**2024 Request for Proposals for Off Island Capacity
Questions & Answers**

Last updated: March 18, 2024

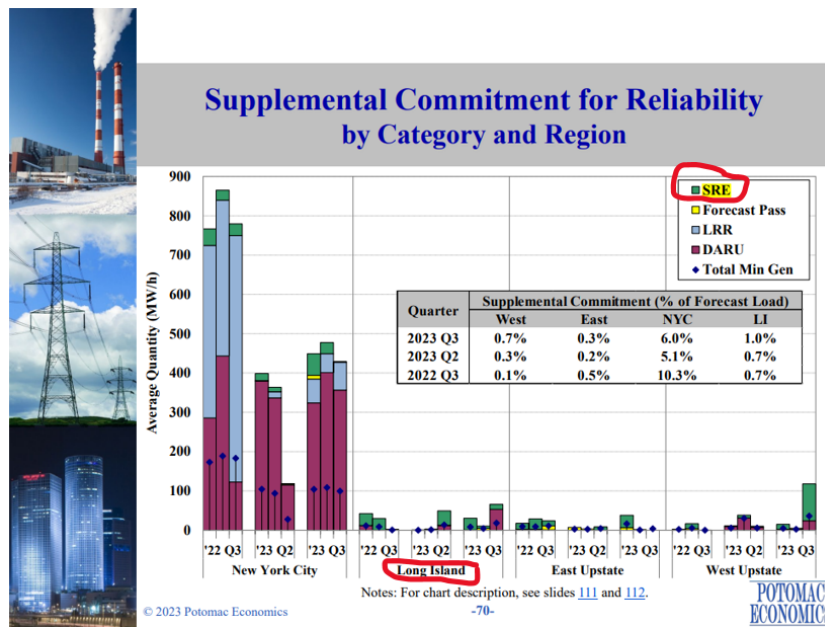
11. **Please see below the excerpt from the EMM report [nyiso.com]. What do these SREs represent? Are these SREs in which NYISO requested resources from Long Island to run?**

The chart appears to show SRE requests for Long Island. We are not aware of any SRE Calls for external resources across the Cross Sound Cable by NYISO in recent history.
